# INSTRUCTIONS FOR FITTING MOTOR WITH TRANSISTORISED SPEED REGULATOR.

## TO MODELS EL 3300 EL 3301/00.

Fig. 1

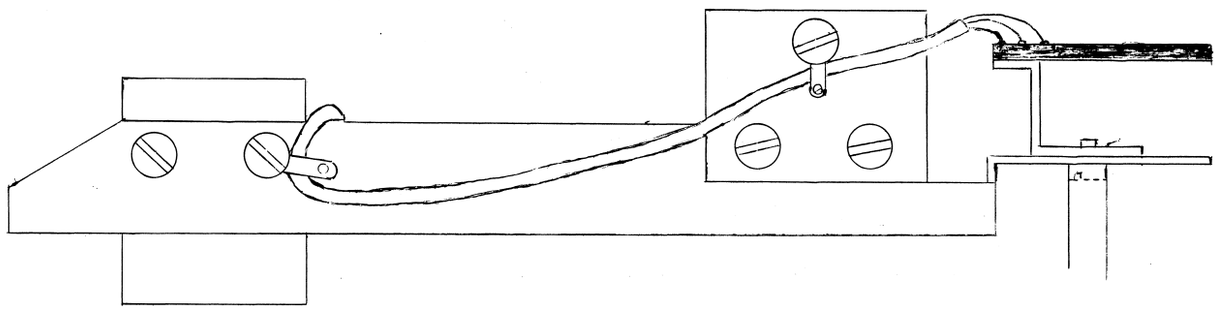
f. Ream the freed hole in the chassis to 3 mm; do the same to the flat spring.
g. Secure the motor print with a 2.6x8 screw, next to the flywheel underneath the indicator, Also secure the flat spring of the indicator with this screw, see fig. 1.

h. Fit a soldering tag under one of the screws of the flywheel bracket and under one of the screws of the motor screening, see Fig. 1.
i. Mount the switch with an M2x12 screw.

Fig. 2

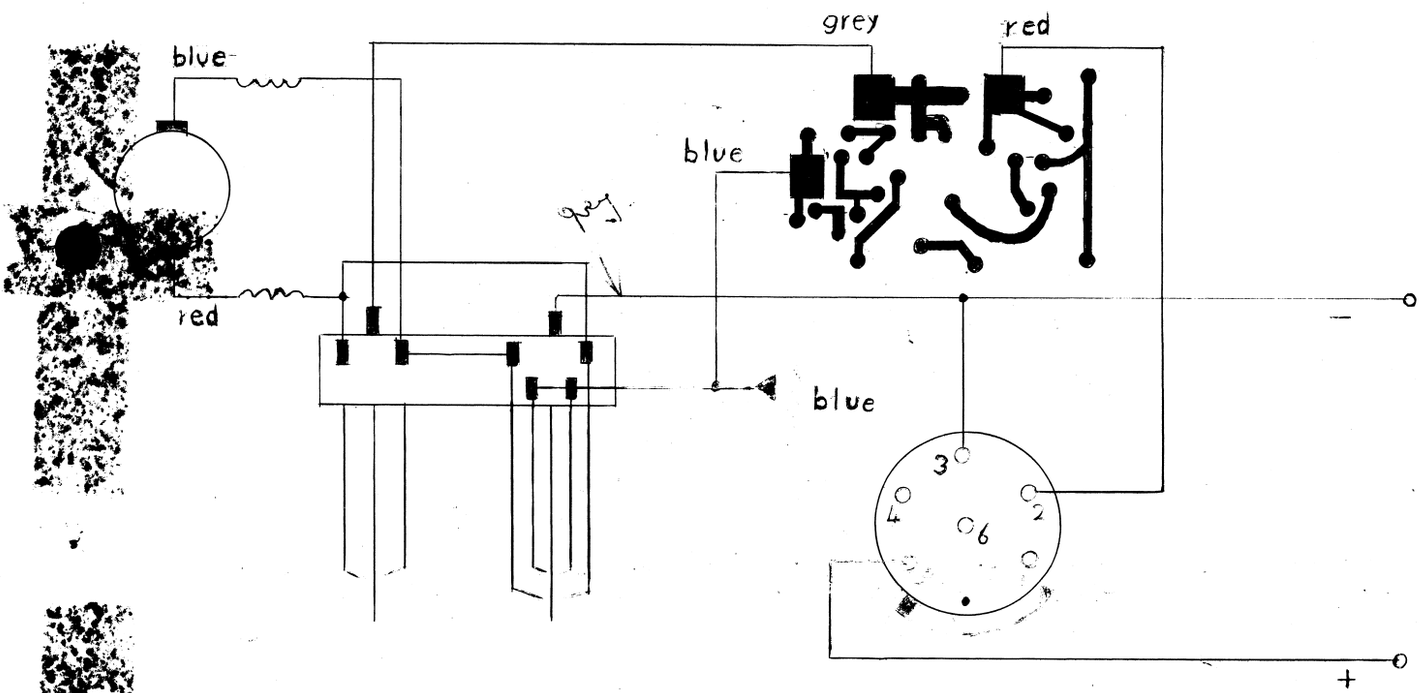
j. Run the wire from the print to the switch along the chassis and secure it by means of the two soldering tags.
k. Then connect the switch and the motor as indicated in Fig. 2.

Fig. 3

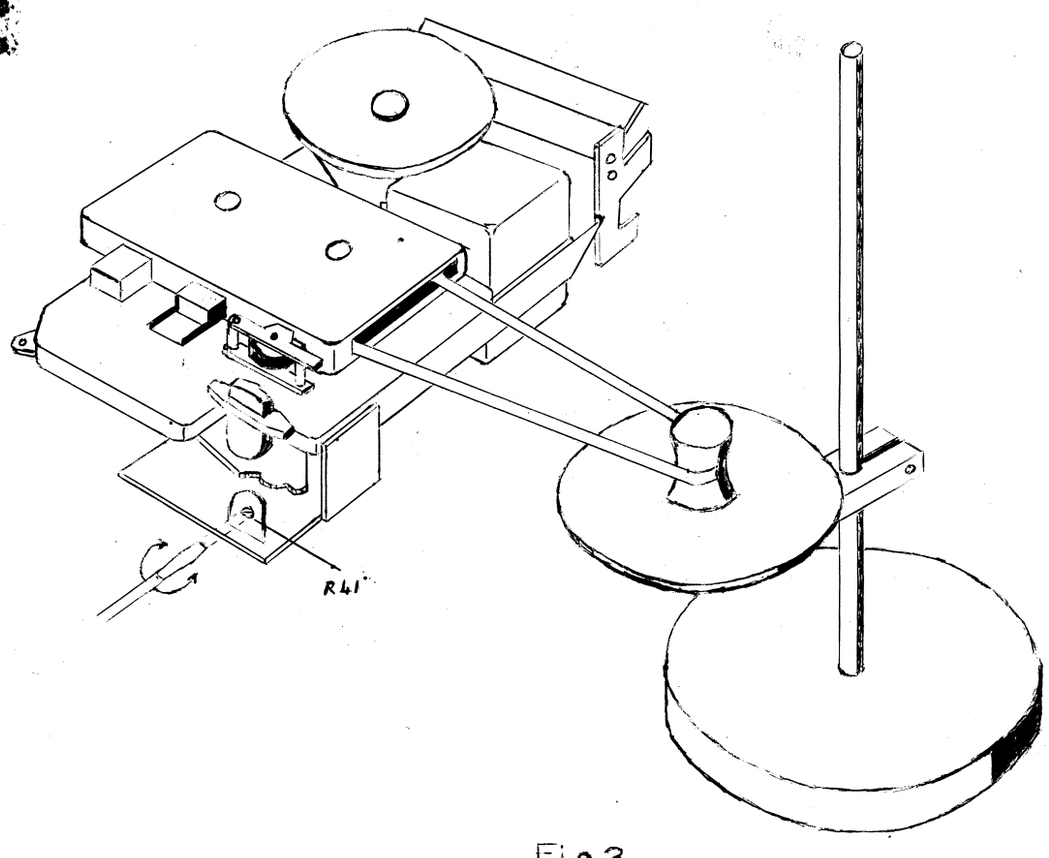
l. Adjustment of the motor speed, see fig. 3.

This speed can be adjusted with R41, fig. 3.
Since it is impossible in this way to check the speed with the standard test tape, the following method should be applied.
One of the sides of a cassette is removed.
This can be done easily with the aid of a knife and a file.
All burrs should be removed from the opening.
The tape can be pulled outside through this opening.
Completely remove the apparatus from the cabinet and insert the cassette.
Position a stroboscope disc (code number A9 407 30/50 for 50 c/s and A9 407 30/60 for 60 c/s) next to the apparatus and lead the tape past this disc, see Fig. 3.
The speed can then be adjusted by turning R41 with the aid of a small screwdriver.
